# **Annual Monitoring Report**

Middle South Muddy Stream Restoration Site

Subject: Revisions to Middle South Muddy Restoration Monitoring Year 2 (MY2) Report; NCDMS Project #93875

Figure 2. Integrated Current Condition Plan View

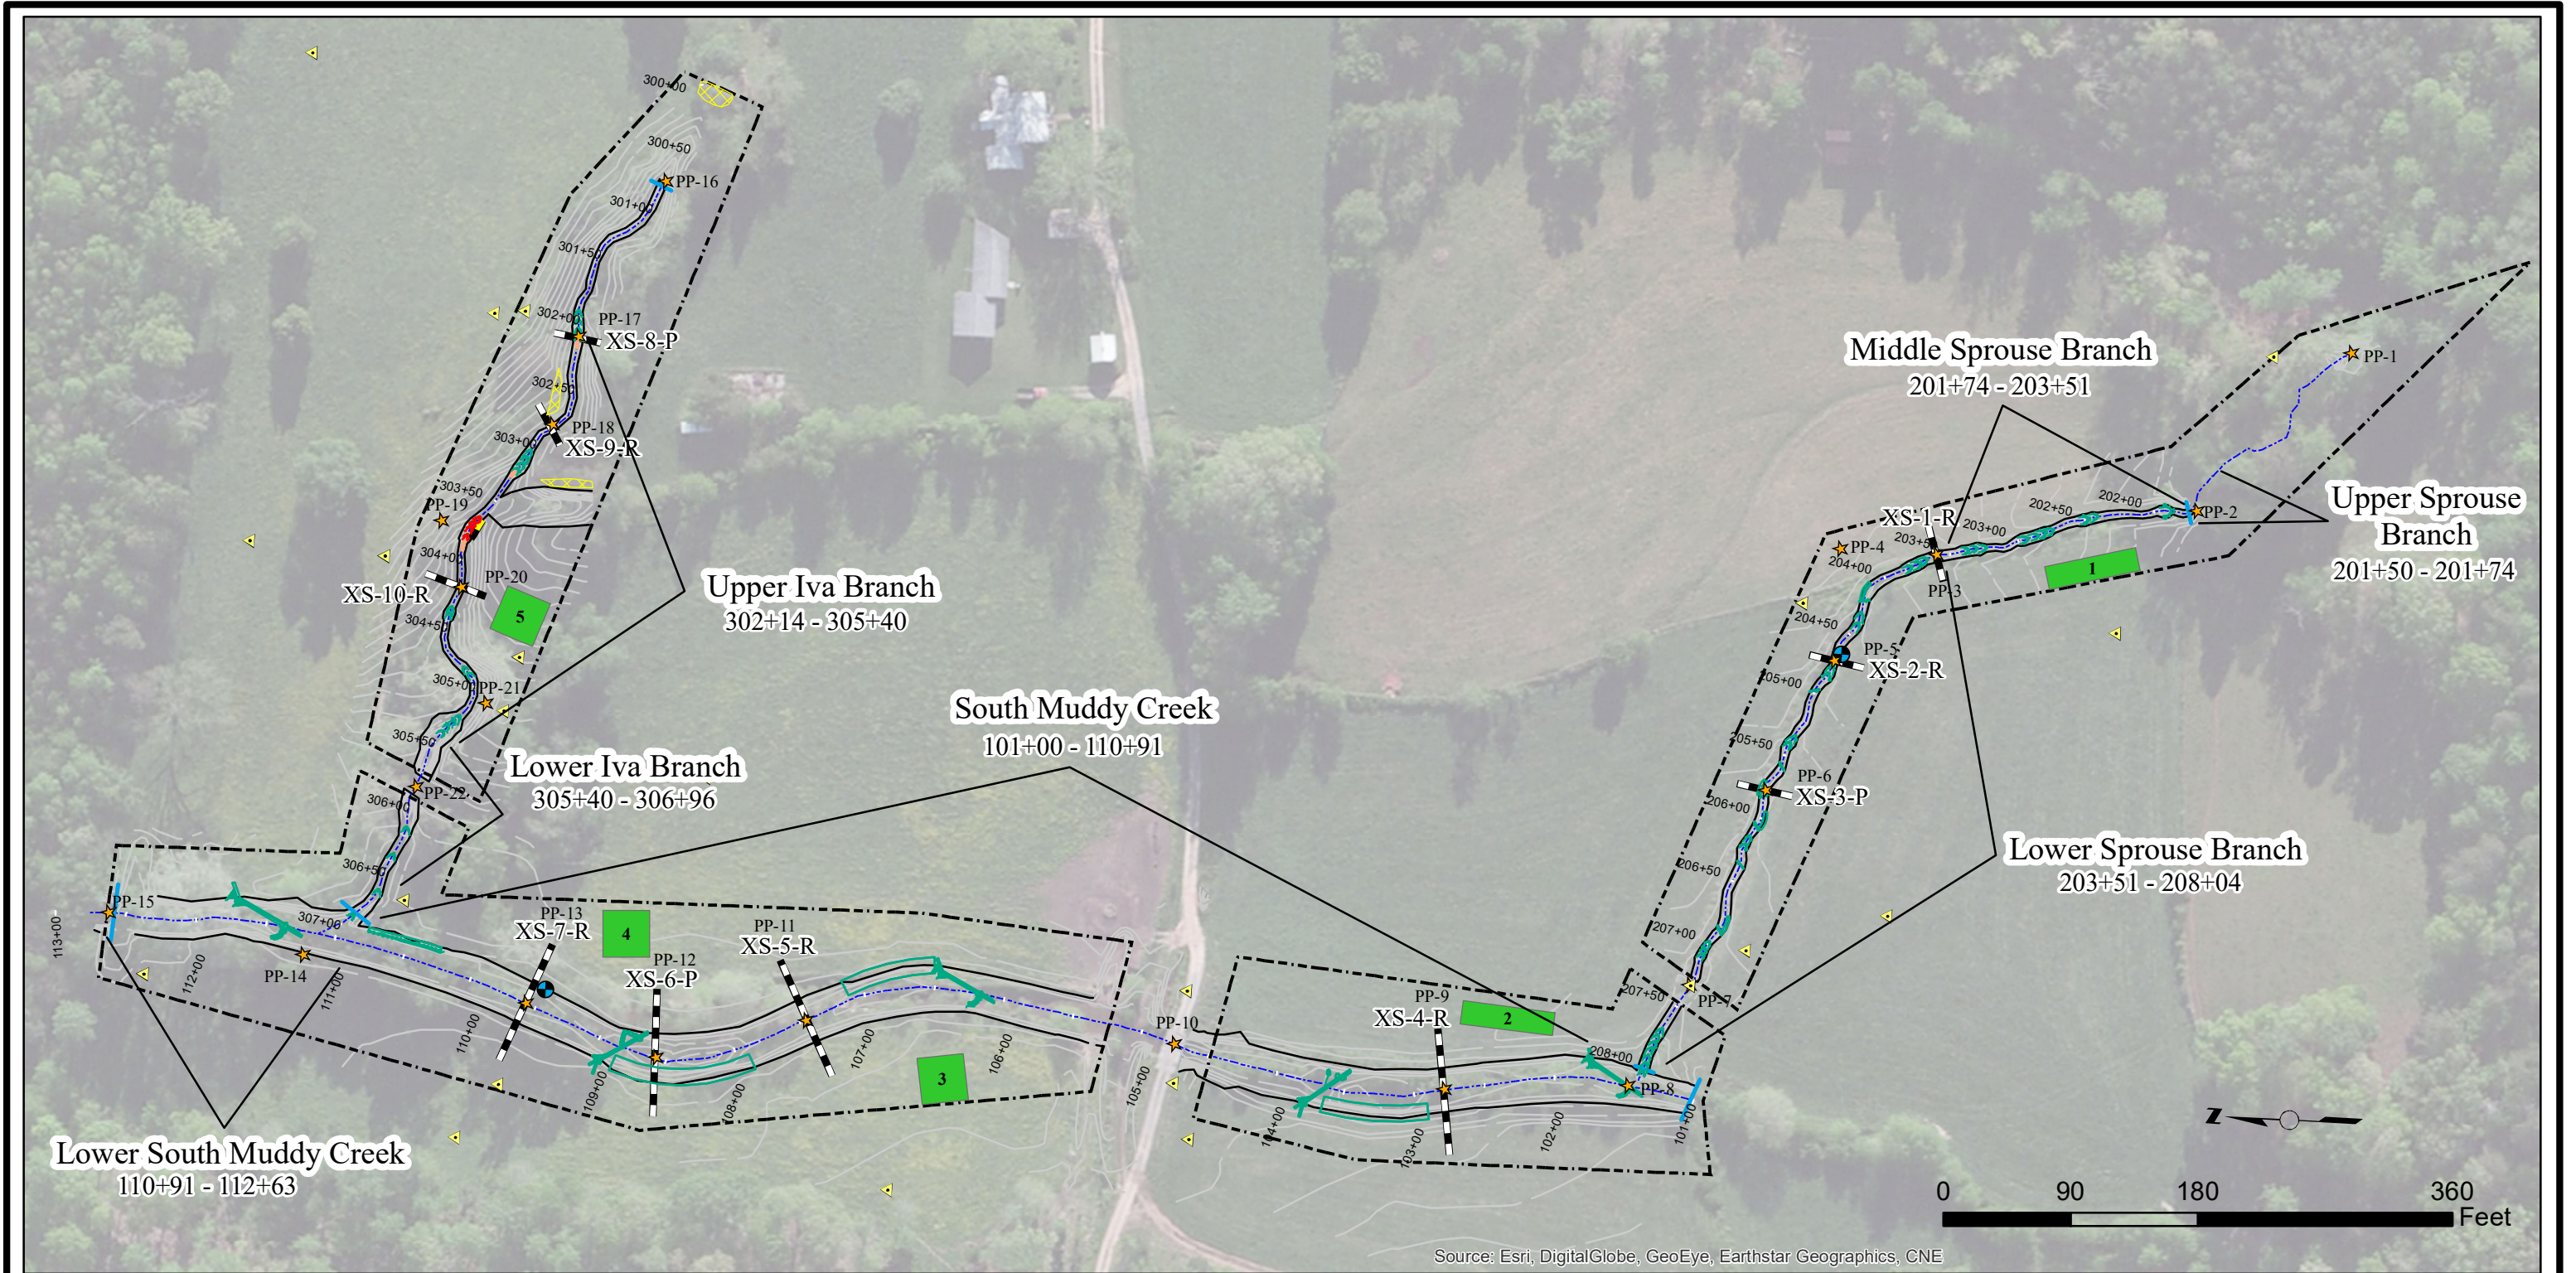
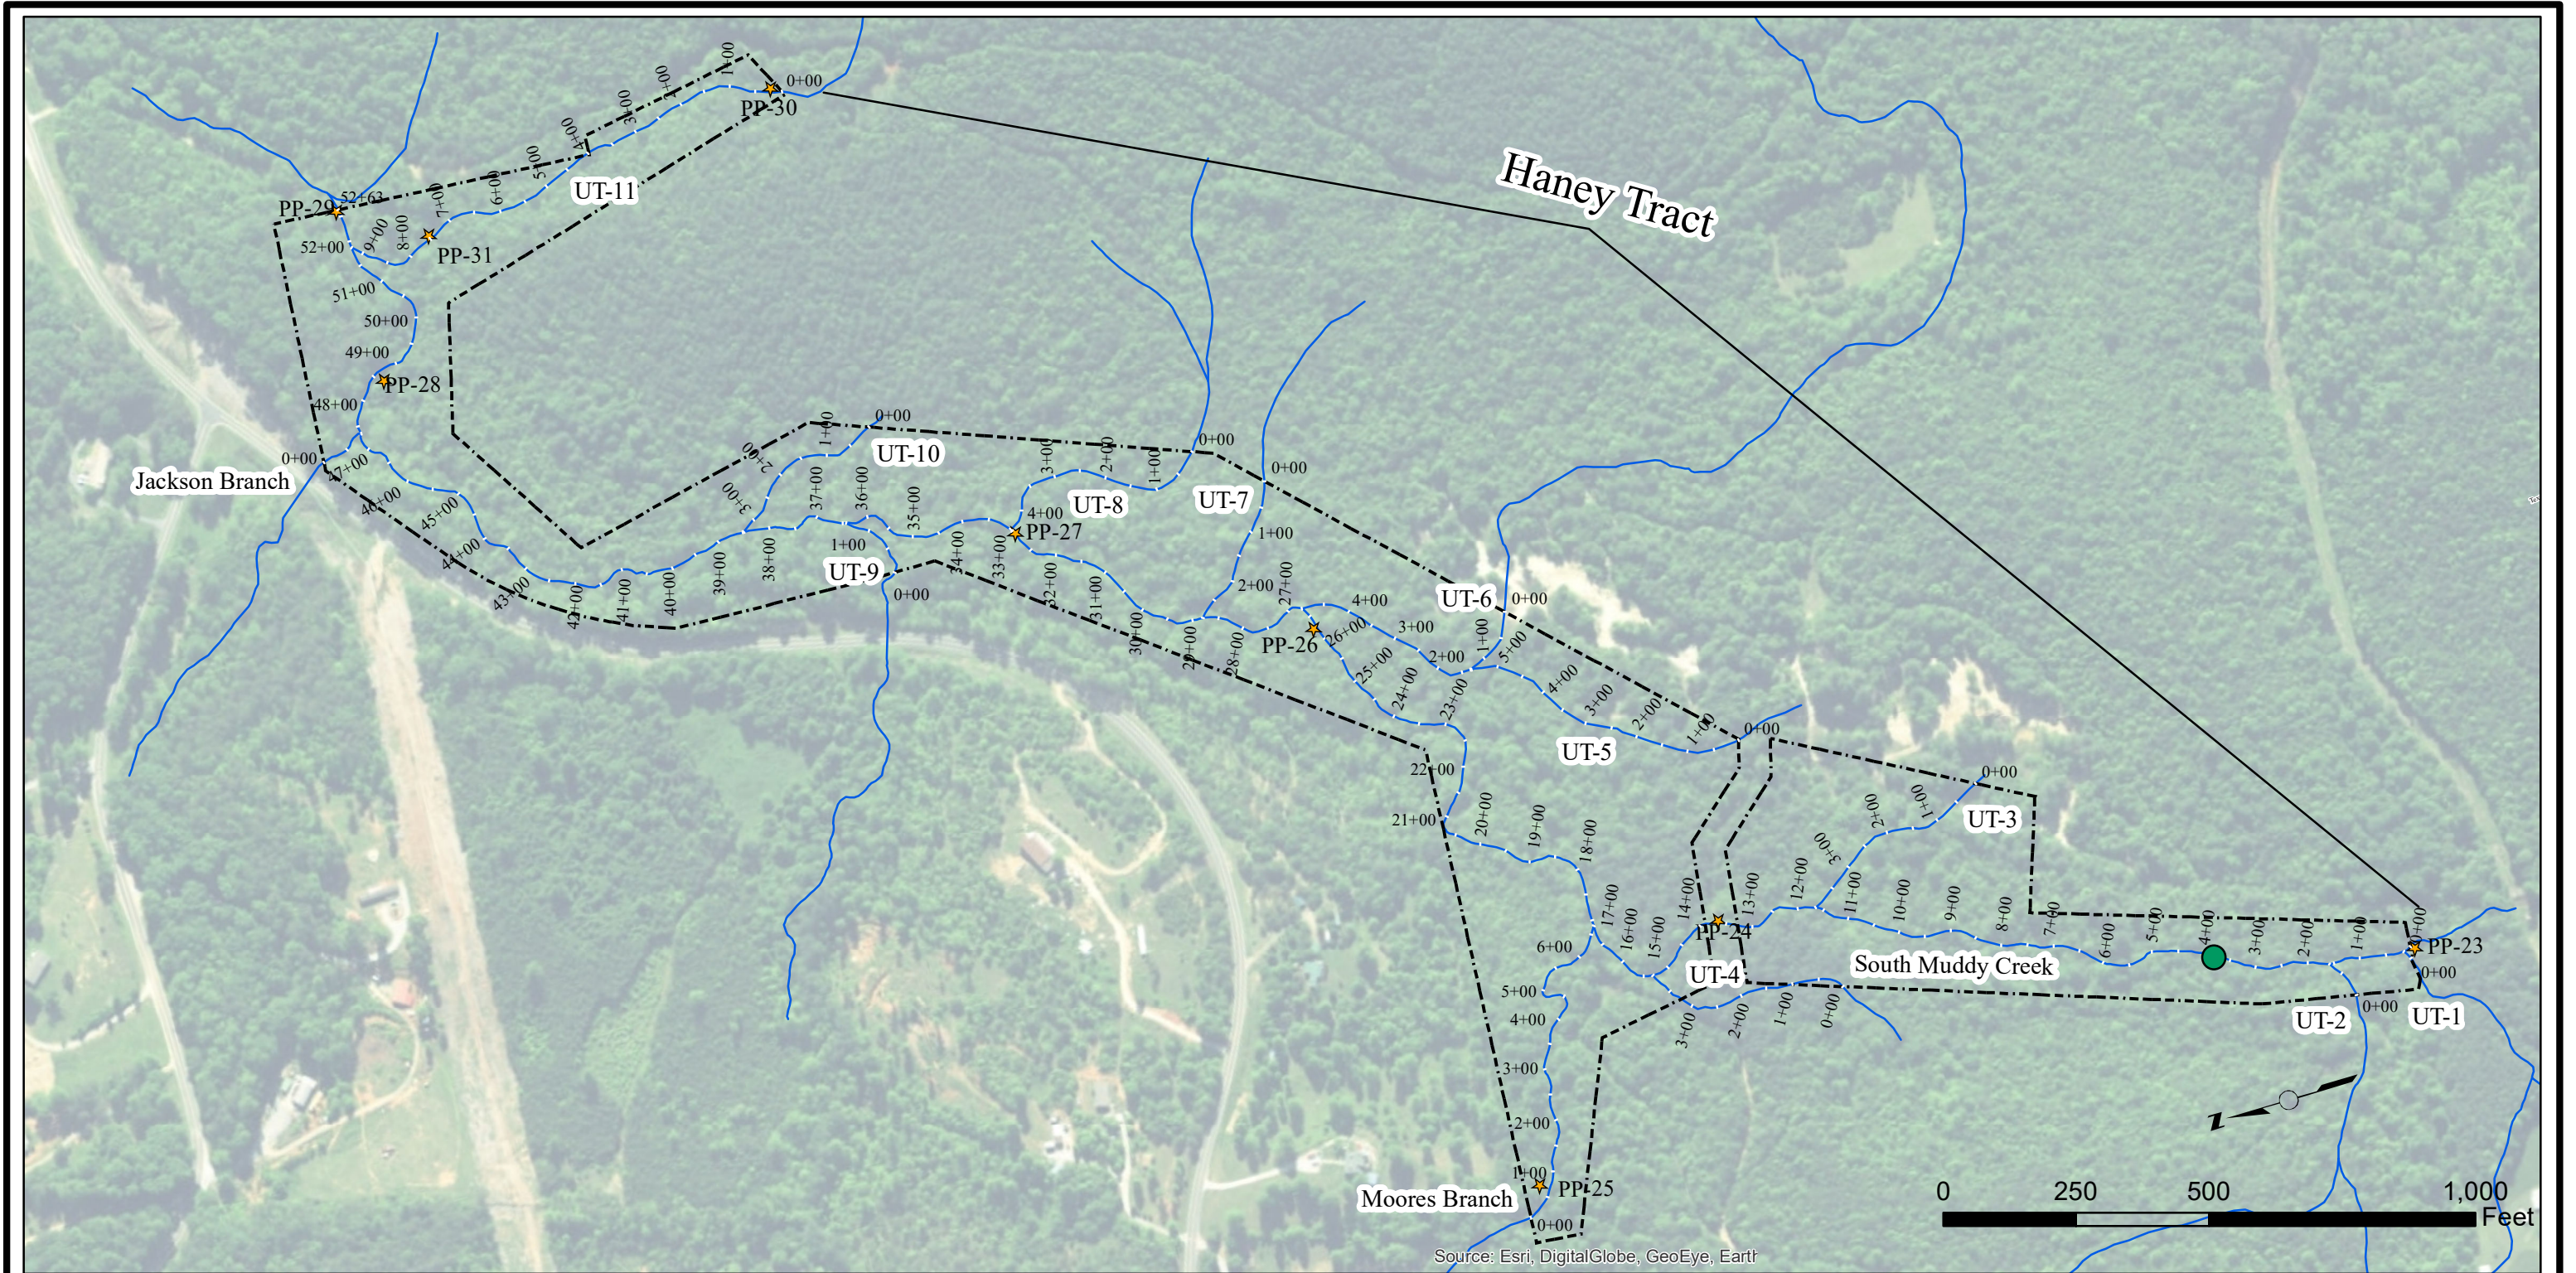
- Report indicates structure at STA: 108+83 that was previously classified as being stressed has stabilized between MY1 and MY2. The structure is shown on the CCPV as being stressed. Table 5 also indicates the structure is stressed as well as a problem area photo on page 43. If the structure has stabilized, please update report sections to reflect this. Also, the section indicates the downstream riffle has stabilized, but the CCPV and Table 5 show it as degraded. Please verify and update as necessary. The stressed structure has been removed from Table 5, the CCPV and the problem area photo on page 43. Table 5 and the CCPV has also been changed to reflect the stabilization of the riffle just downstream of the structure.
